Video Products Technical Bulletin 30-2004-002

DATE: **January 12, 2004**SUBJECT: **VERTICAL LINES WAVE HORIZONTALLY IN UPPER PICTURE**

MODEL: ***BVM-D14H1A***
BVM-D14H1E
BVM-D14H1U
BVM-D14H5A
BVM-D14H5E
BVM-D14H5U

Figure 1

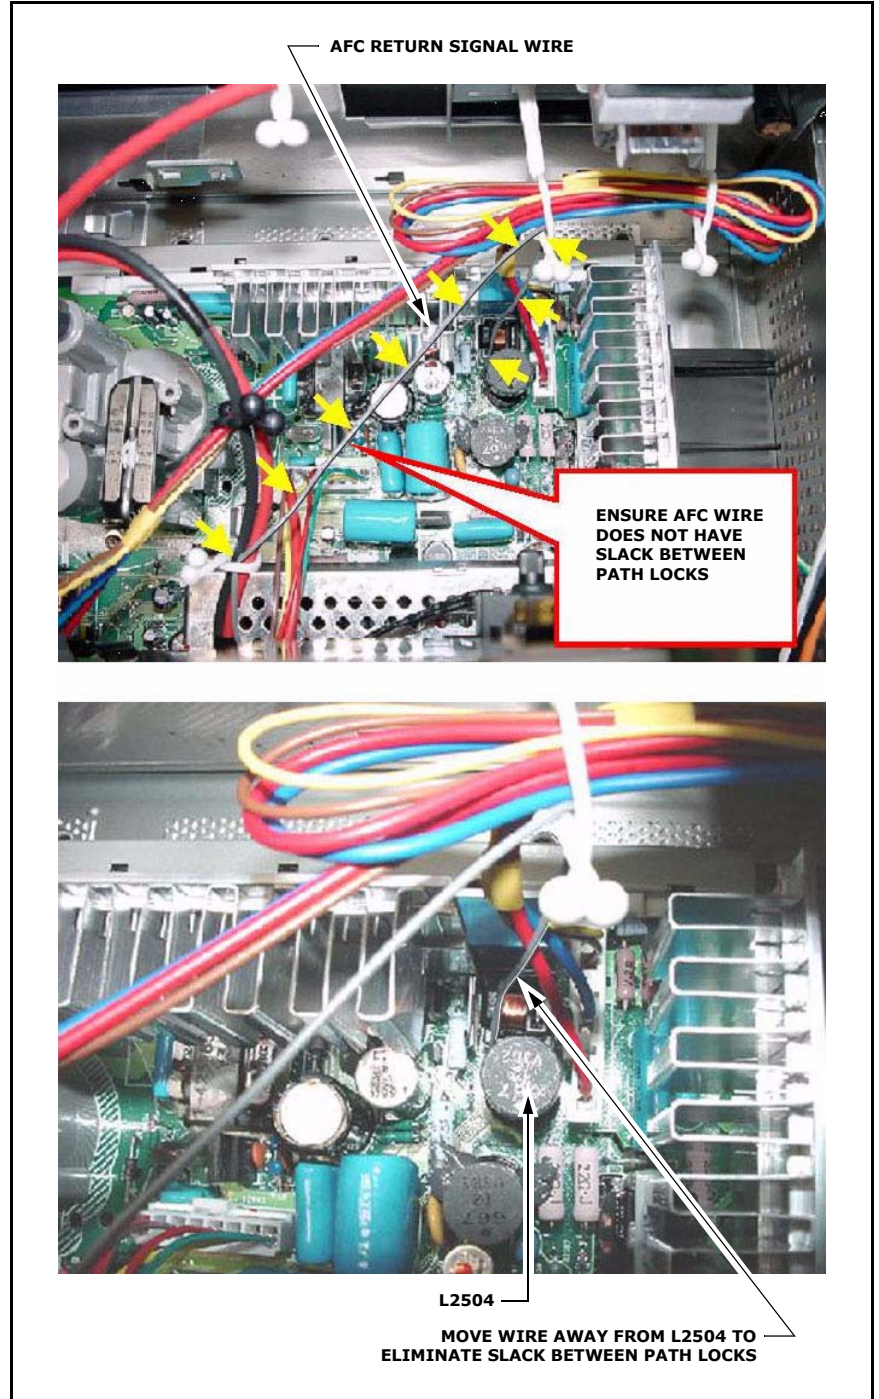
- Secure the AFC return signal wire (gray) soldered between L2504 (HLC) and IC515 (PWMIC) so that the wire does not contain slack and is kept away from L2504. (See Figure 1.)

- If vertical lines still appear in the upper part of the picture, replace the G board with a new suffix -13 G board.

Figure 2

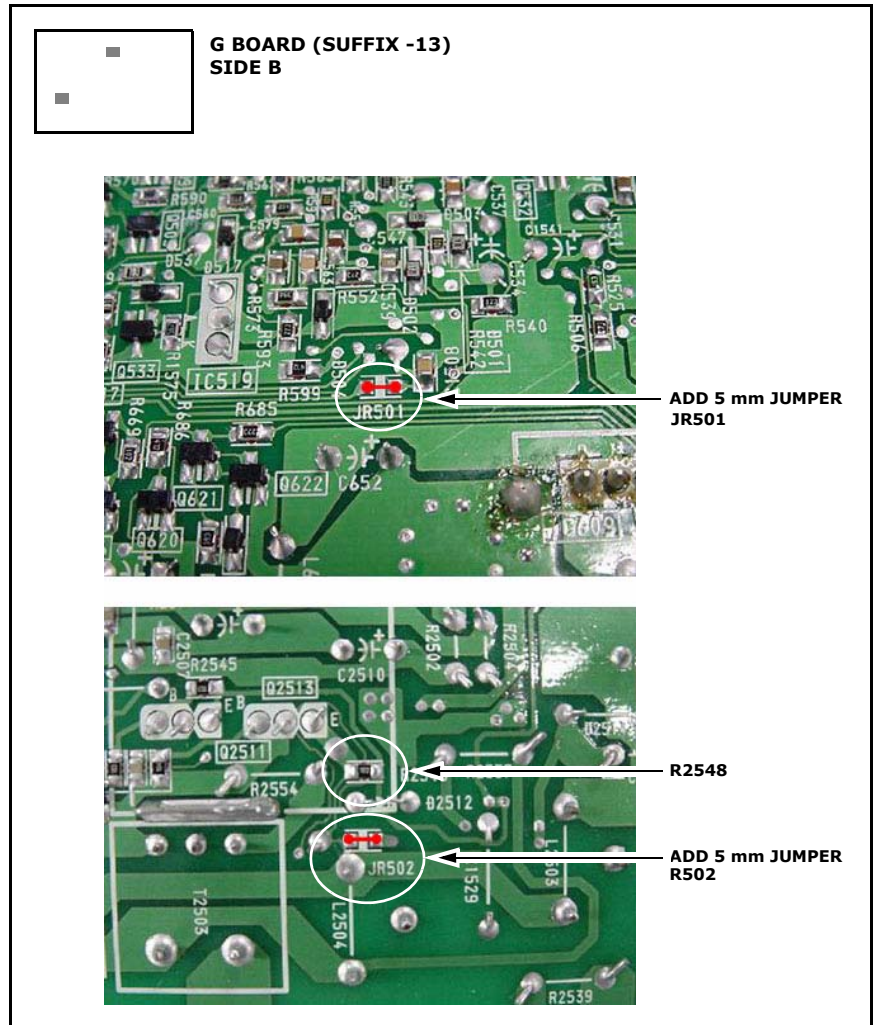
6. Solder a 5 mm jumper to JR501 (near C652) and a 5 mm jumper to JR502 (near L2504) as shown in Figure 2.

NOTE: A gray AFC wire is not used in suffix -13 G boards. A conductive trace is used instead.
